APPLICATION NO.	FILING DATE	FIRST NAMED INVENTOR	ATTORNEY DOCKET NO.	CONFIRMATION NO.
10/088,451	06/12/2002	Helmut Klein	BM-85PCT	2843

Office Action Summary

- 1) ☒ Responsive to communication(s) filed on 23 February 2004.
- 2a) ☒ This action is **FINAL**. 2b) ☐ This action is non-final.
- 3) ☐ Since this application is in condition for allowance except for formal matters, prosecution as to the merits is closed in accordance with the practice under *Ex parte Quayle*, 1935 C.D. 11, 453 O.G. 213.

FIG. 4

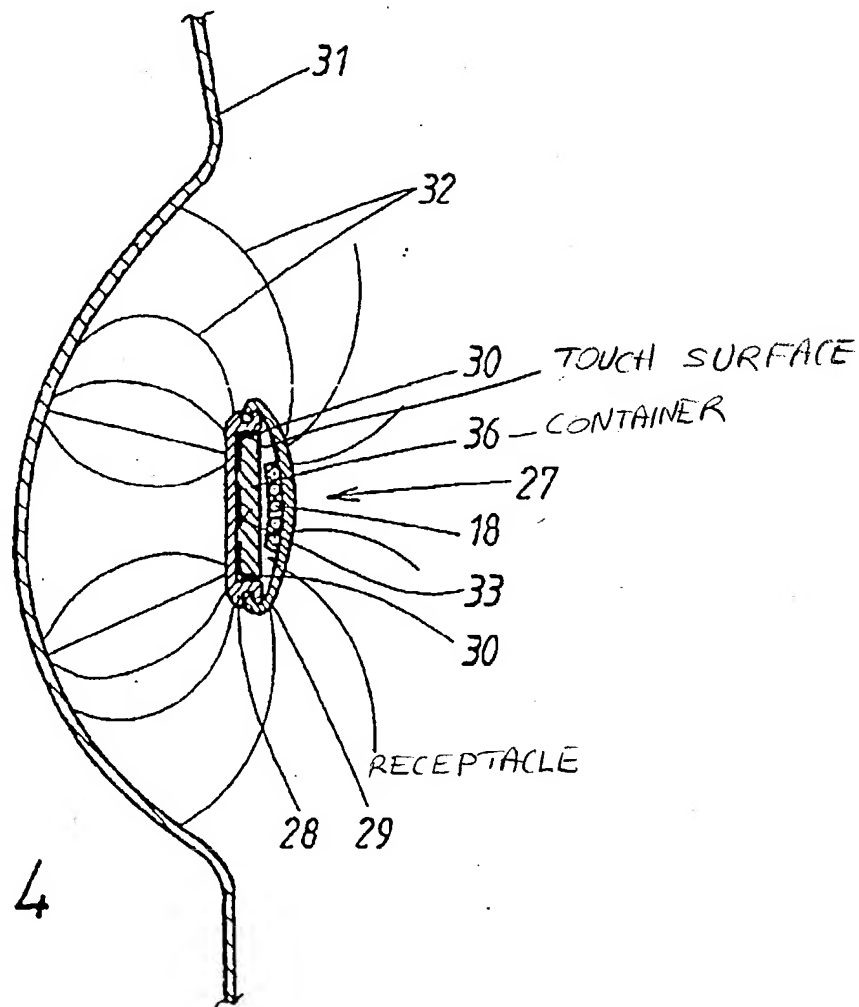
Regarding claim 12, the container 36 is of a unitary configuration and the switching element 30, 33 is enclosed in its container interior (Fig. 4).

FIG. 3

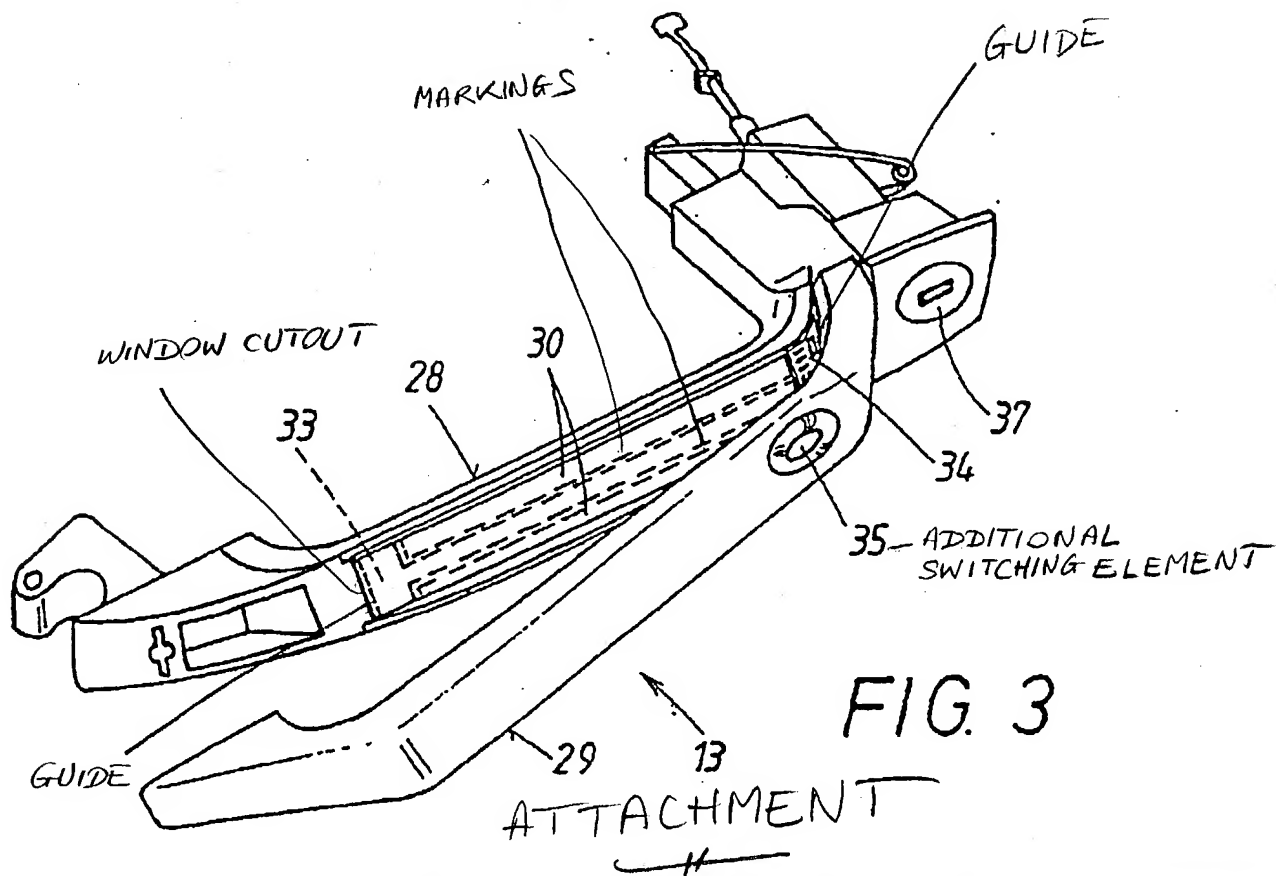
Regarding claim 1, Boom et al. (which corresponds to US Patent No. 6,075,294) teaches a closing system for motor vehicles, comprised of a handle 13 comprised of two shells 28 and 29, one of which is a base shell, and a lock 37 on the vehicle on at least one door 12 as well as an electronic control 16, wherein the lock 37 can be switched between two states, i.e., a first state, preventing opening of the door 12 and a second state, allowing opening of the door 12, and wherein in the area of the handle 12 at least one switching element 30, 33 is arranged with which the electronic control 16 can be activated, via which the lock 37 can be transferred from its first state into the second state allowing opening of the door 12, wherein the switching element 30, 33 is in a container 36 integrated water-tight, and the container 36 on at least one side has a touch surface (i.e., a top surface of the container 36, see Attachment) for actuating the switching element 30, 33 and the container 36 is introduced without play into a receptacle (Att.) of the base shell 28 of the handle 13, and the base shell 28 of the handle 13 has a window cutout (Att.) in its

outer wall (Att.) in the area of the receptacle (Att.) in which, when the container 36 is inserted into the receptacle (Att.), the touch surface (Att.) is positioned in a form-locking manner (see the translation in USP 6,075,294, column 4, lines 33-66).

Claim 1 and other claims below are anticipated by Boom because when Boom's handle 13 is in disassembled state as show in Boom's Fig. 3, the user can touch the outer surface of Boom's container 36. Therefore, the outer surface of Boom's container 36 is "read on" the claimed "touch surface." It is well settled that anticipation law requires distinction be made between invention described or taught and invention claimed. It does not require that the reference "teach" what subject patent application teaches, it is only necessary that the claim under attack, as construed by the Court, "*read on*" something disclosed in the reference, *i.e.*, all limitations of the claim are found in reference, or are "*fully met*" by it. *Kalman v. Kimberly Clark Corp.*, 218 USPQ 781, 789 (CAFC 1983). On the other hand, a recitation of the intended use of the claimed invention must result in a structural difference between the claimed invention and the prior art in order to patentably distinguish the claimed invention from the prior art. If the prior art structure is capable of performing the intended use, then it meets the claim. In a claim drawn to a process of making, the intended use must result in a manipulative difference as compared to the prior art. See *In re Casey*, 152 USPQ 235 (CCPA 1967) and *In re Otto*, 136 USPQ 458, 459 (CCPA 1963). In addition, note that the functional limitations of a claim may not be given patentable weight where those limitations are inherent in a prior art reference. *In re Schreiber*, 44 U.S.P.Q.2d 1429 (CAFC 1997).
